Development Services Department  
Staff Recommendations Concerning Required Findings

Project Name &  
Case Number: **Davis Water Treatment Plant - SPC-2012-0414(R1)**

Variance Request: **To allow construction within 150-foot Critical Environmental Feature (CEF) buffer for a Rimrock CEF [LDC 25-8-281(C)(2)(b)].**

## **ENVIRONMENTAL COMMISSION MOTION 20200415 006c**

C-01

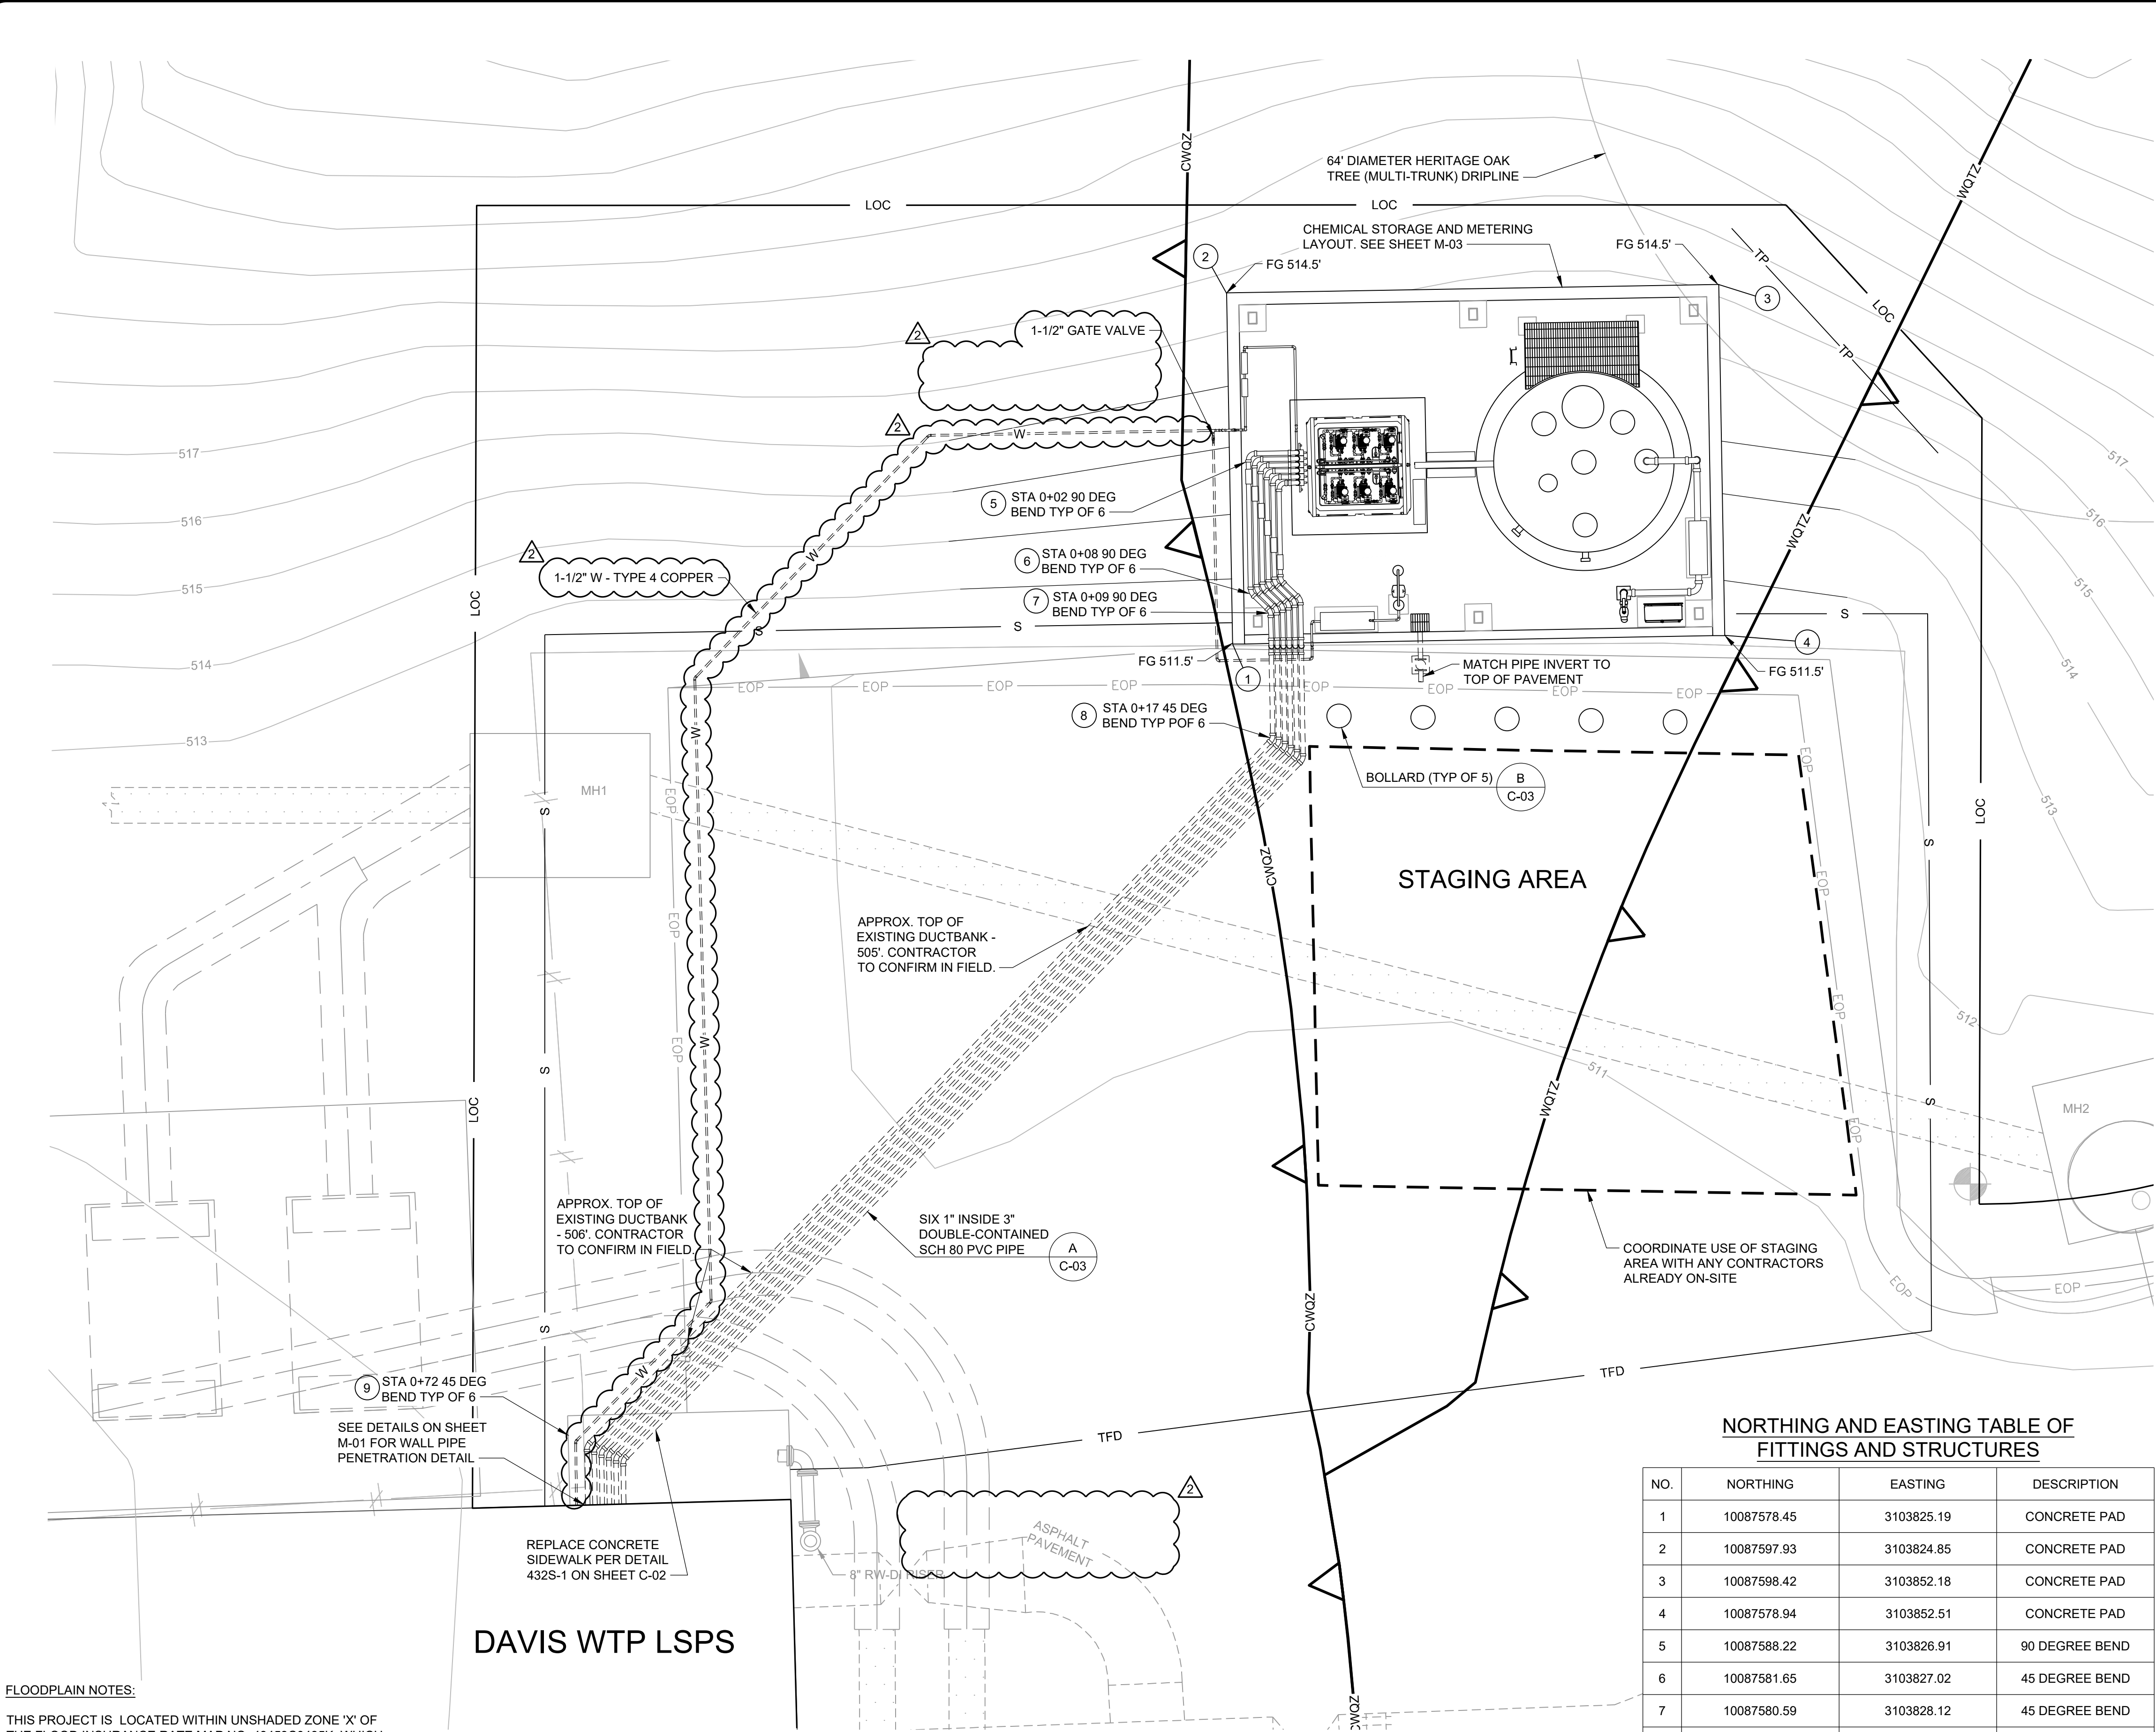
**Yes The variance is not necessitated by the scale, layout, or construction method. It is necessitated by the steepness of the slope (40 percent) at the edge of the site where the concrete pad is proposed to be located. The cut is necessary for the concrete pad that will house the chemical feed system. The proposed pad location is 1) close to the freshwater intake, minimizing the amount of construction needed for laying the pipes; 2) outside of both the Critical Water Quality Zone for Lake Austin and the Water Quality Transition Zone for Huck's Slough, maximizing distance from the adjacent bodies of water; and 3) on the far side of the site from the seep, spring, and rimrock Critical Environmental Features.**

**Yes     The variance does not create a significant probability of harmful environmental consequences. The cut will be stabilized by a wall on three sides of the concrete pad.**

Clearly indicate in what way the proposed project does not comply with current Code (include maps and exhibits)	<ul style="list-style-type: none"> <li>The back of the concrete pad will require 5.5' of soil excavation. LDC limits excavation to a depth of 4'.</li> </ul>
---	--

**THEREFORE**, the Environmental Commission recommends approval of the requested variances from LDC 25-8-281 (C)(2)(b) to allow construction within the 150-foot buffer of Critical Environmental Features and LDC 25-8-341 to allow cut to 5.5 feet with the following;
